***Analysis and Report on Sections 4.1 through 4.6 of the Comments of the  
Keweenaw Bay Indian Community (KBIC)—Final***

Prepared for the United States Environmental Protection Agency – Region 5

by The Cadmus Group, Inc. under contract # EP-C-08-015

September 2009

Figure 4-1. Cross section along transect E-E' through TWIS area.

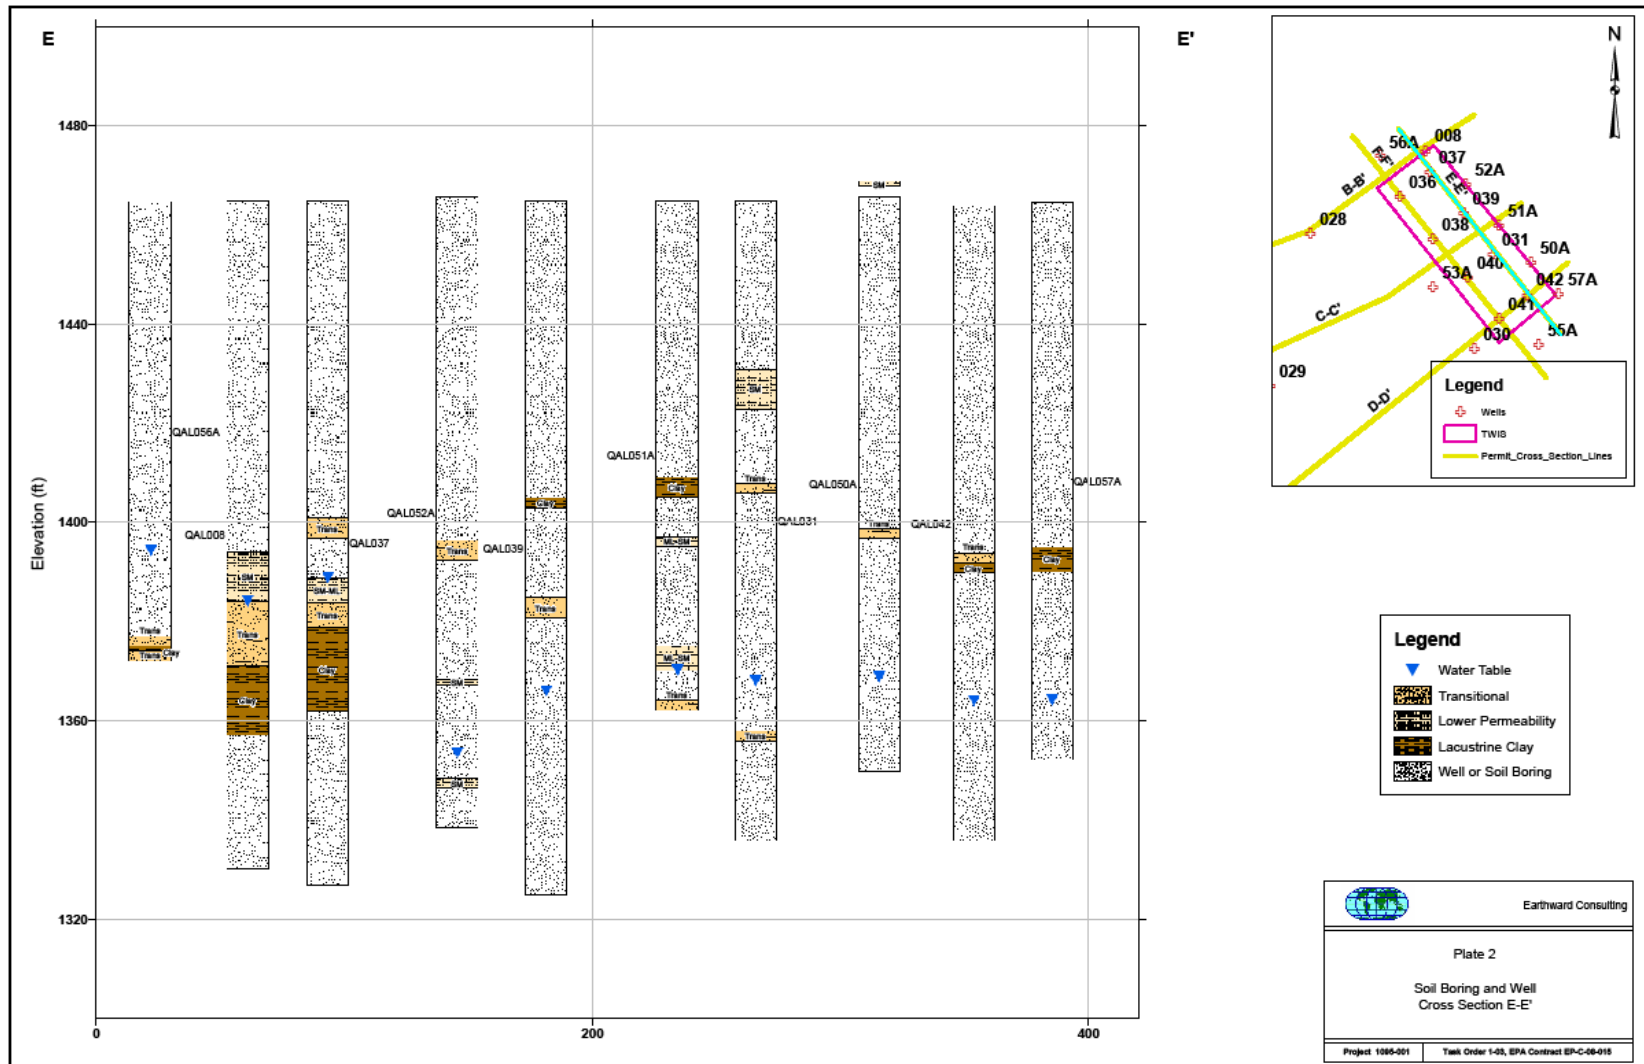
Figures 4-1 and 4-2 show that the transitional layer, while present in most of the well and boring logs, does not occur at a consistent depth and is generally quite thin. Such an observation is consistent with the transitional deposit being present as discontinuous lenses and makes any argument for their continuity highly questionable. Silty sand layers (coded SM) in the unsaturated zone are similarly irregular (e.g., occurring at different depths in different logs, and appearing as one layer in some logs and two or three in others) in their appearance across boreholes. It is concluded that the lower permeability sediments are laterally discontinuous and significant mounding of treated wastewater that would breach the land surface is unlikely.

It should be pointed out that when evaluating the appearance of the lower permeability layers in the cross-sections, the subjectivity inherent in boring logs should be kept in mind. The transition between, for example, a sand layer and a silty sand layer may be gradual rather than sharp, and differentiation may be subtle depending on the difference in composition.

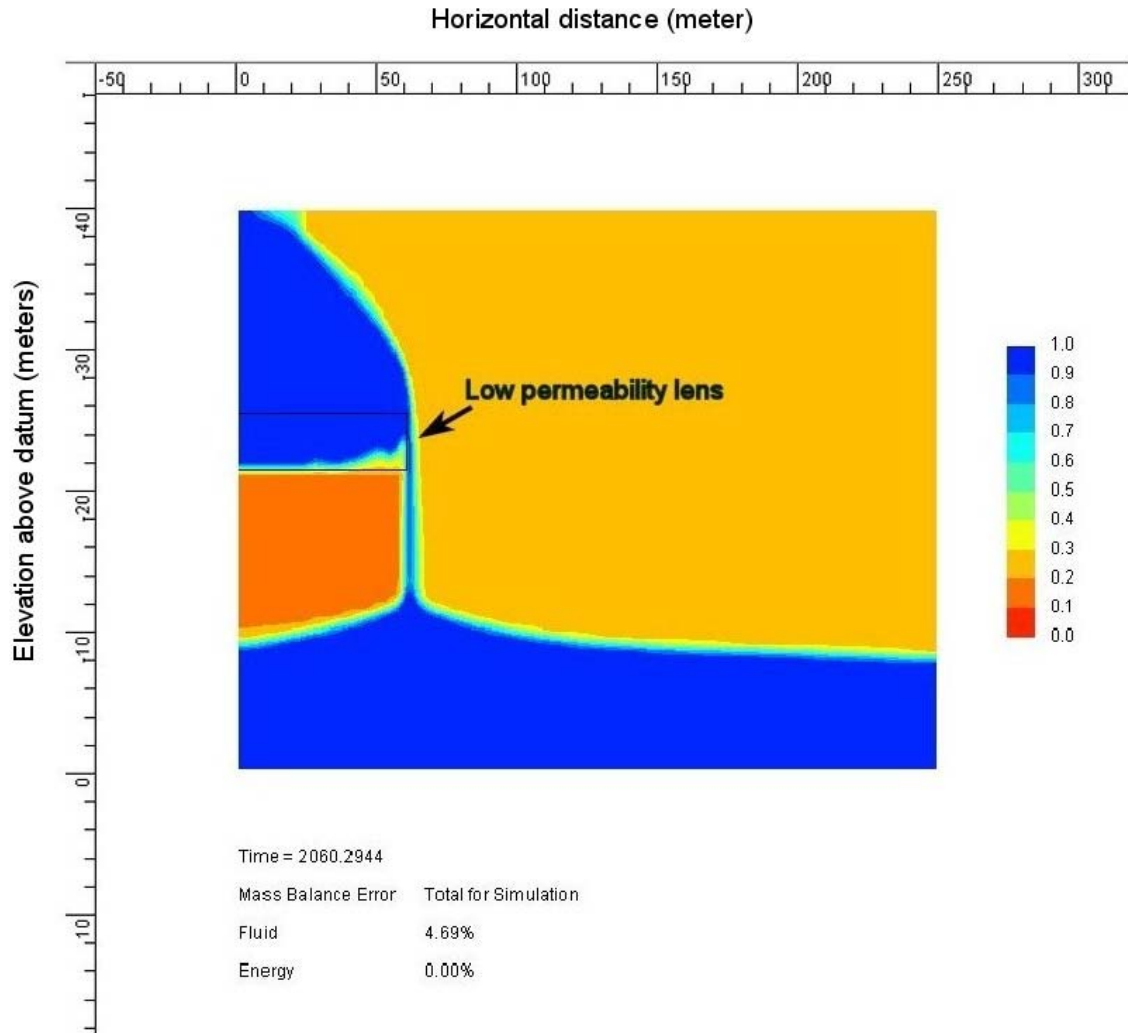
KBIC's consultants provided the results of their numerical simulations and also provided the two data sets used to generate those results. These data sets were used to re-run the simulation and verify the results. The graphics from the post processor shown below (Figure 6-1) match Figure 4.17 in the KBIC Comments. Note that there is a 2,000 day equilibration phase in the model before the 60 days of infiltration are simulated. This equilibration phase simulates the establishment of baseline conditions prior to infiltration.

Mass balance should ideally be less than 1%. Although not discussed by the KBIC Comments, these runs experienced mass balance errors of almost 5% (see Figure 6-1). The reason for higher error is most likely the time stepping or convergence control parameter selected. As is, the execution takes hours to run. Because of the strong hydraulic conductivity contrast (over two orders of magnitude), it is unlikely that revisions to achieve a lower mass balance would substantially change the overall model predictions.

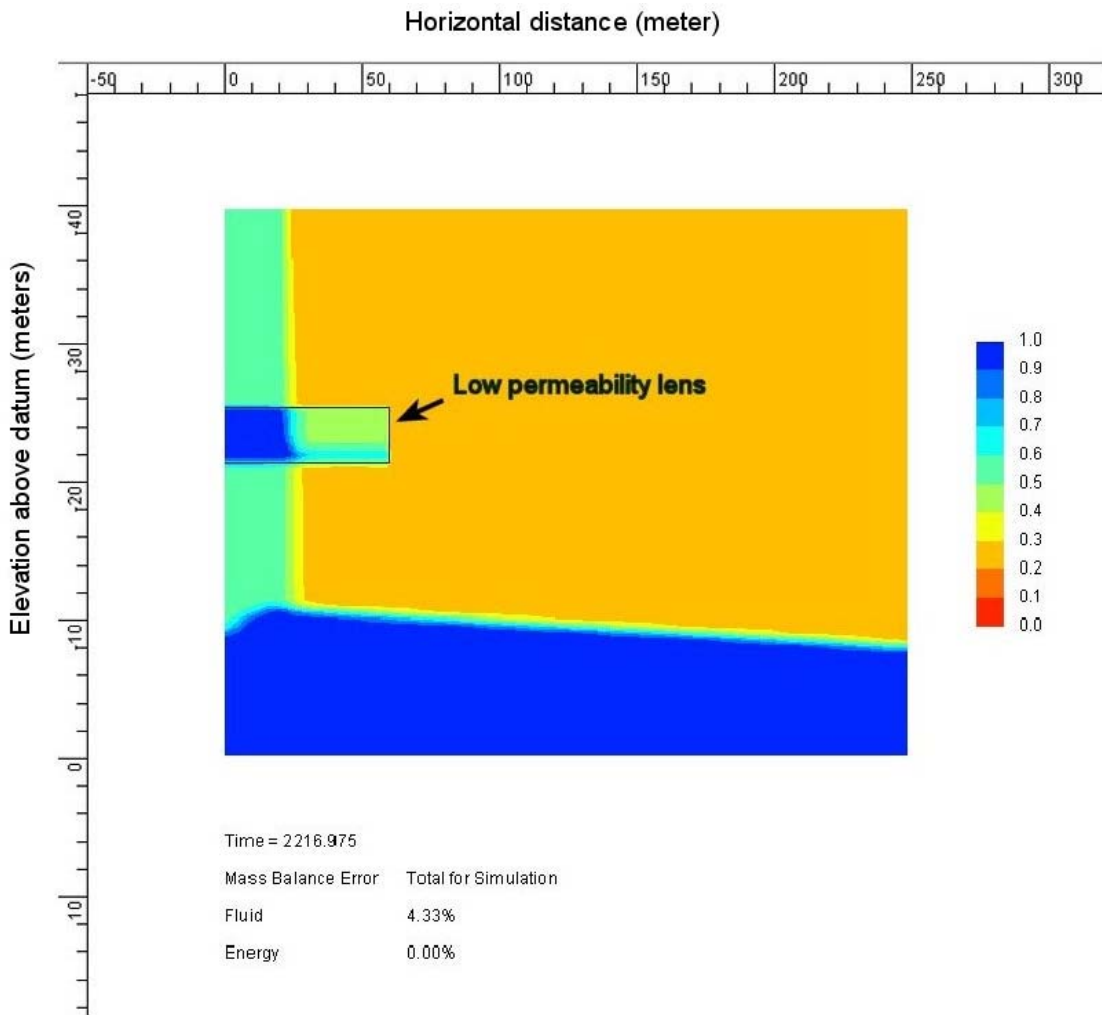
The model used by KBIC’s consultants is highly dependent on the assumed saturated conductivity of the silty sand (SM) material as well as the location and thickness of this unit. To demonstrate this, the assumed hydraulic conductivity of the silty sand was changed for this review from 0.009 m/day to 0.225 m/day, a value still within a reasonable range. (The value selected by KBIC’s consultants is the lower limit (0.00864 m/day) as taken from Fetter (2001; Table 4.3 of the KBIC Comments); the upper limit from this same source is 0.864 m/day.) Using

this alternative assumed hydraulic conductivity changes the ratio of the hydraulic conductivities of sand and silty sand from 233 (=2.1/0.009) to 9.3 (=2.1/.225). In the model, this involved selecting a silty loam soil instead of “silt CP” for soil type.

The simulation was re-run with all other parameters unchanged. First, a 2,000 day equilibration period was simulated. Subsequently, infiltration was simulated using the same TWIS recharge rate for a period of 217 days, allowing conditions to stabilize. Unlike the case reported in the KBIC Comments, the results do not exhibit flooding near surface conditions (100% saturation), but rather a 50% saturation as show below (Figure 6-2).

Figure 6-3. Taken from Bower (2002, Figure 10).

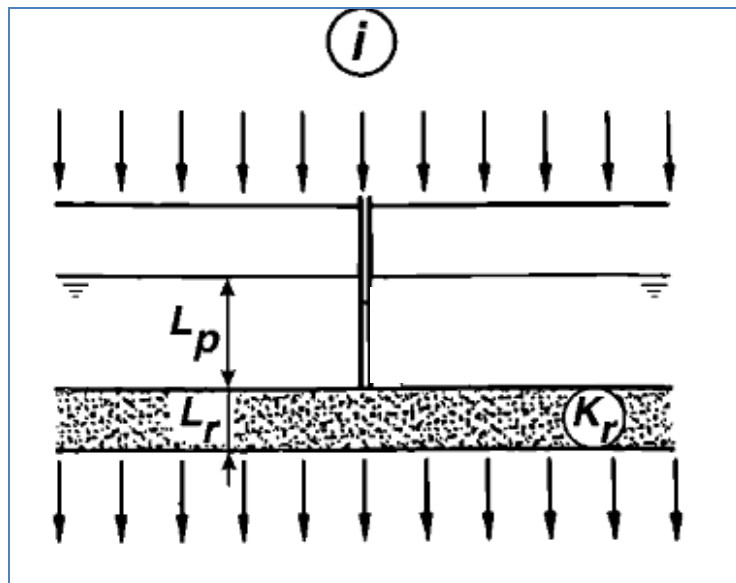
Assessment of the hydraulic conductivity value in the lower-permeability sediments that might lead to mounding to the surface can be done based on work by Bower (2002) (Figure 6-3):

This calculation produces a limiting hydraulic conductivity of 0.18 ft/day. Assuming a 13-foot thick lower-permeability layer, there will only be flooding at the ground surface due to mounding if the hydraulic conductivity of the 13-foot layer is less than 0.18 ft/day (0.06 m/day). This value lies approximately half way between the upper and lower bounds for hydraulic conductivity for silty sand given by Fetter (2001) (Table 5-1), and towards the lower end of the range given by Freeze and Cherry (1979) (Table 5-1). As noted above, Kennecott’s consultants had used the lower bound of Fetter’s values in their modeling. The conclusion that a hydraulic conductivity of 0.18 ft/day could cause mounding to the ground surface also assumes, as stated above, that a lower conductivity layer is continuous. As discussed in previous sections, the genesis of the subsurface sediments at the site and the stratigraphy as described in the boring logs and cross sections strongly suggest that such a continuous layer does not exist in the TWIS area.
